Access Compliance Report

Public Rights-of-Way

(Pedestrian Signals)

Intersection ID: N/A	Main Street:	Cross Street: N/A	Location: N/A
ADA ID: A8E6FCFA9D4F	Signal Type: One Push Button-APS	Overall Compliance: No	Severity Score: BTN 1: N/A BTN 2: N/A No BTN: N/A
Codes/Mitigation Info/Possible Solution		Field Measurements/Component Compliance

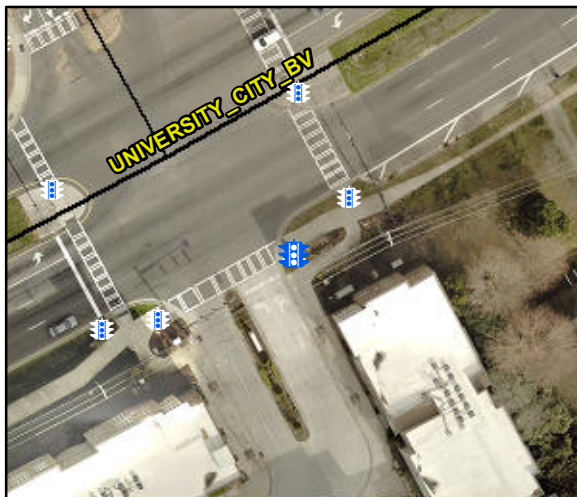
PROW/ADA: TMUTCD 4e.08, R404.2, R404.3, R404.7.2, R209.1, MUTCD 4e.10,

N/A	B 1 Clear Xing Direction?	Yes	N/A	B 2 Clear Xing Direction?	N/A
	B 1 Crossing Direction	To SW		B 2 Crossing Direction	N/A
Yes	B 1 DistanceTo XWalk (in)	0.0	N/A	B 2 DistanceTo XWalk (in)	N/A
No	B 1 DistanceTo Curb (in)	166.0	N/A	B 2 DistanceTo Curb (in)	N/A
Yes	B 1 Diameter (in)	2.0	N/A	B 2 Diameter (in)	N/A

Possible Solutions: Replace Signal Push Button With APS Button on New Post. Remove & Relocate Sign.
